Table 3.3.1-1 (page 4 of 8)
Reactor Trip System Instrumentation

PART D
PACKAGE 3.7
PLANT SYSTEMS

PART G
PACKAGE 3.7
PLANT SYSTEMS

CL3.3-252

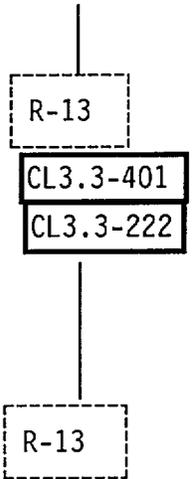
- ~~Containment SprayCS High High Containment Pressure - High 3 (High, High) (two, three, and four loop units); and~~
- ~~Containment Phase B Isolation Containment Pressure - High 3 (High, High) which is a one-out-of-two channels, three-out-of-three sets logic.~~

~~None of these signals has input to a control function. Thus, two-out-of-three logic is necessary to meet acceptable protective requirements. However, a two-out-of-three design would require tripping a failed channel. Condition E addresses the situation where containment pressure channels are inoperable. With channel(s) tripped, one or more of the three sets may be actuated. This is undesirable because a single failure would then cause spurious containment spray initiation. Spurious spray actuation is undesirable because of the cleanup problems presented. Therefore, these channels are designed with two-out-of-four logic so that a failed channel may be bypassed rather than tripped. Note that one channel may be bypassed and still satisfy the single failure criterion. Furthermore, with one channel bypassed, a single instrumentation channel failure will not spuriously initiate containment spray.~~

~~To avoid the inadvertent actuation of containment spray and Phase B containment isolation, the inoperable channel should not be placed in the tripped condition. Instead it is bypassed. Restoring the channel to OPERABLE status, or placing the inoperable channel in the tripbypass condition and verifying one channel in each pair remains OPERABLE within 6 hours, is sufficient to assure that the~~

Difference Category	Difference Number 3.3-	Justification for Differences
CL	222	CTS allows containment pressure channel inputs to containment spray logic to be tripped when one or more are inoperable. The PI logic is one-out-of-two channels, three-out-of-three sets. ITS LCO 3.3.2 Condition E has been modified to account for the PI unique logic.
